CORRIGENDA

Installation procedure leaflet contain misdescription. Refer to the following table and confirm the descriptions that are corrected.

* PGQW2444ZA *

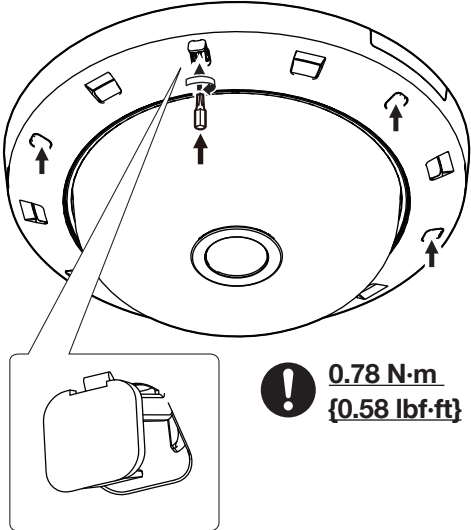
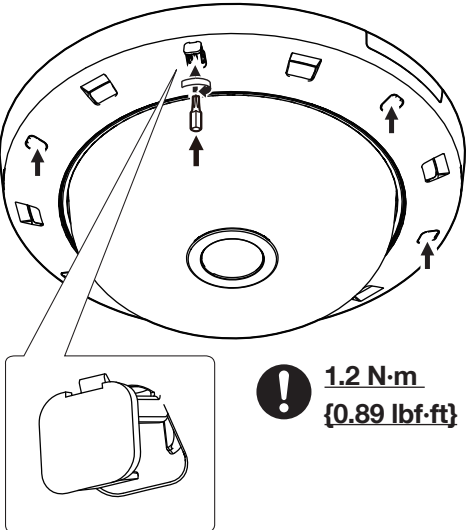
Incorrect	Correct
<p data-bbox="145 370 285 426">Step7</p>  <p data-bbox="560 751 767 813">! <u>0.78 N·m</u> <u>{0.58 lbf·ft}</u></p>	<p data-bbox="823 370 963 426">Step7</p>  <p data-bbox="1241 751 1449 813">! <u>1.2 N·m</u> <u>{0.89 lbf·ft}</u></p>

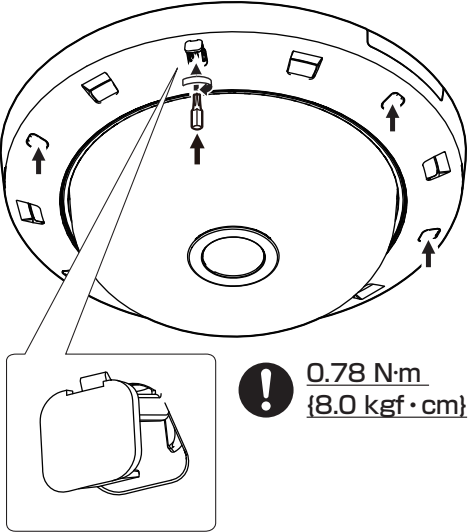
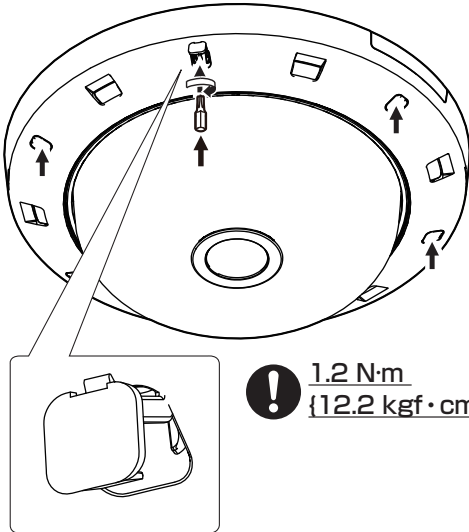
設置手順チラシに記載の誤りがありました。以下に内容を記載します。

誤	正
<p data-bbox="145 337 288 393">Step7</p>  <p data-bbox="544 712 775 768">! <u>0.78 N·m</u> {8.0 kgf·cm}</p>	<p data-bbox="823 337 967 393">Step7</p>  <p data-bbox="1222 712 1469 768">! <u>1.2 N·m</u> {12.2 kgf·cm}</p>
